MEETING OF DESIGN REVIEW BOARD
THURSDAY, NOVEMBER 20, 2025 - 4:00 PM

**Planning Staff Report to
Design Review Board
November 12, 2025**

Docket Number:	25-924
Applicant:	Kirk Crawford
Property Owner:	Main at McBee Hospitality, LLC
Property Location:	30 E. McBee Ave and 2 E. McBee Avenue
Tax Map Number:	0059000100100; 0059000100700
Zoning:	MXS-D, Downtown Design Review Boundary
Proposal:	CA for Site Plan, Massing, Detailing, and Demo
Staff Recommendation:	Approve with conditions

The applicant is requesting approval for the site plan, massing, and architectural detailing for a new 7-story hotel with accompanying sidewalk upfits; to include 149 guest rooms; ground level restaurant; and guest amenities including meeting rooms, fitness room, functional space, etc.

Site Plan

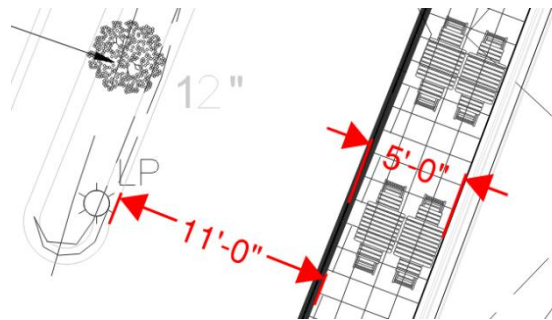
- PUB 1 – Block Pattern
 - The proposed development will create an active structure in place of a parking lot, keeping under the recommended block length, and with a structure conforming with the development code's maximum building length. Per PUB 1.2 the development will tie into existing sidewalks and will improve upon them with new paving, street trees, parking, and furnishings.

- Vehicle access is occurring at an existing curb-cut located as far away from the Main Street intersection as site-parameters allow, per PUB 1.6 and 1.7. Smaller curb radii are being employed per PUB 1.9, and on-street parking is being converted to drop off spaces.

- The Main Street facing building edge is being constructed 5' inside of the property line and is creating an additional 5' of building transition zone which exceeds the minimum recommendation of 4' per PUB 2.1. This will leave intact the 11' pedestrian travel route on Main Street behind the historic Halprin planters.

- The McBee sidewalk will provide between 14' and 25' of pedestrian space which will allow for an upgraded sidewalk, additional plantings, tree wells, and outdoor furnishings. Per PUB 2.4, the resultant space is enough to absorb the higher pedestrian traffic expected for the hotel entrance and drop-off area.

- PUB 6 – Building Transition Zone
 - Furnishings for the building transition zone are provided per plan and are located against the building edge adjacent to the pedestrian route of travel as recommended. The area is appropriately sized for restaurant service, **although direct access to the bistro tables should be enhanced with additional service doors. Furnishing specifications shall require an additional review by staff and two members of the DRB prior to the issuance of the final Certificate of Appropriateness (“CA”).**

- Decorative pavers are appropriately indicated at all primary thresholds but are not specified. **Pavers shall require additional review by staff and two members of the DRB prior to issuance of the final CA.**

- PUB 7 – Alleys and Pedestrian Cut-Throughs
 - A single service corridor is located between this project and the adjacent building to the south to provide emergency egress and utility access. The service corridor is not visible from the public right-of-way and must be adequately lit per building code. The corridor is gated and screened from the Main Street sidewalk. Plans indicate a decorative iron gate

treatment and screening, but exact type is not yet specified. **Gate and screening shall require additional review by staff and two members of the DRB prior to issuance of the final CA.**

- An on-street drop-off lane is being proposed adjacent to the hotel entrance. This area is currently dedicated to public parking and is within the city's right-of-way. **Staff will review this substitution of a public function with a private function during the permitting phase and in consultation with city traffic engineering and parking services.**

- Staff recommends a higher-level of paving, planting, signage, and curbing be constructed in this area to highlight the private function and to offset the loss of public space. **Once the private function of this area is approved by the city, the drop-off area shall require additional review by staff and two members of the DRB prior to issuance of the final CA.**

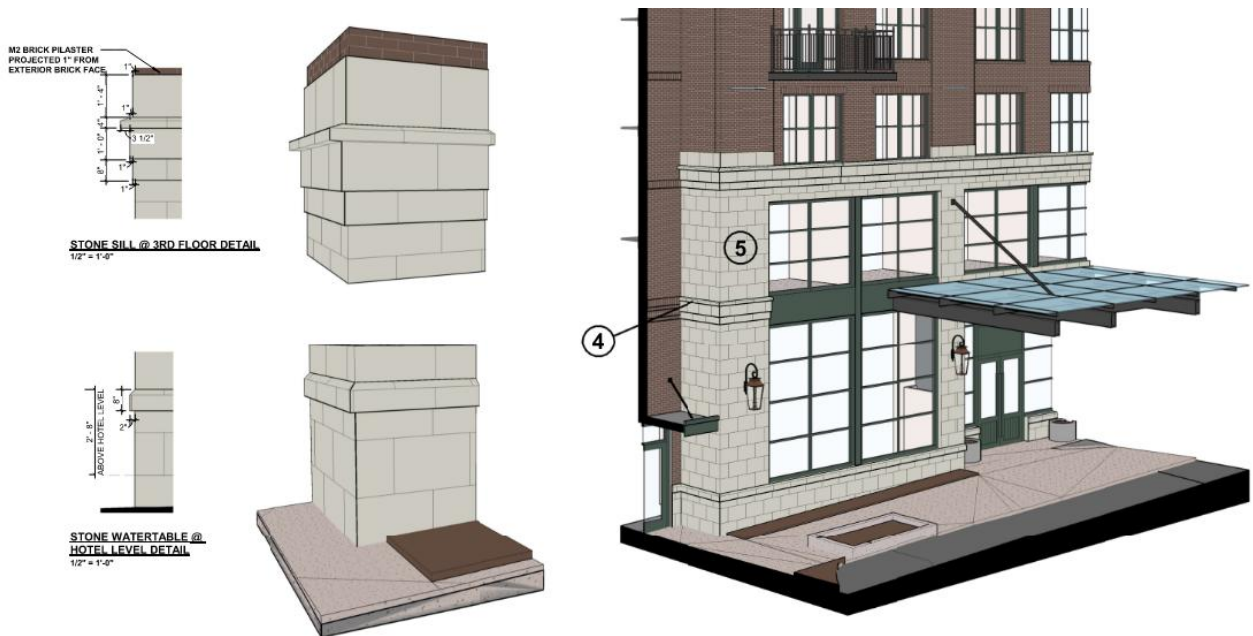
- PRI 1 – Placement
 - Per PRI 1.1 the building face is aligned with the street, and Per PRI 1.2, the internal uses all contribute toward a publicly activated street including hotel entrance, lobby, restaurant, and restaurant entrance. Bicycle racks are provided per PRI 1.3.

- PRI 2 – Massing
 - The building's height of seven stories is not in stark contrast to the surrounding structures. Within a one-block radius, buildings range between two and twelve stories. The floor-to-floor height is conforming, as is the building's width, per PRI 2.1.

- A material change at the first and second floors helps to ground the massing to a pedestrian-friendly scale and aligns with the directly adjacent two-story structure on South Main Street per PRI 2.6.

- Per PRI 2.7, a variety of building heights is encouraged downtown, and the width is proportional to other structures.
- PRI 3 – Entry
 - The McBee Avenue entry is appropriately scaled and located to announce its purpose as a destination per PRI 3.5. **Staff is recommending (but not conditioning) additional glass be added to the doorway sidelights to meet transparency percentage requirements for the MXS-D zoning district.**

- A chamfered corner entry is required per PRI 3.7 and is met by this application.
- No public entrances are provided directly onto Main Street. This creates a relatively long, unbroken façade along the city’s primary pedestrian corridor. The distance between the restaurant corner entry and a service door is 70’. This is far greater than the prevailing Main Street entry spacing which is generally between twenty and forty feet. **As such, it is recommended that an additional public door be added onto Main Street to improve activation and circulation, or an employee door be added to improve the service of the Main Street tables, which are isolated and not easily accessible for restaurant staff. This new door alignment shall require additional review by staff and two members of the DRB prior to issuance of the final CA.**

- PRI 4 – Activated Ground Floor
 - All windows shall be transparent per PRI 4.2, with no dark tinting or reflectivity being allowed.
 - Further activation by the inclusion of an additional door on Main Street is recommended.

- PRI 5 – Articulation
 - The articulation and fenestration of the building façade, primarily at the pedestrian level, are compatible with PRI 5.1 and 5.2. Balconies are provided per PRI 5.5.
 - Window and door treatments are appropriate for Main Street and the architectural style.
 - Stone watertable, sill, banding, and cornice are appropriately detailed, human scaled, and of a material in contrast to the body of the building per PRI 5.4.
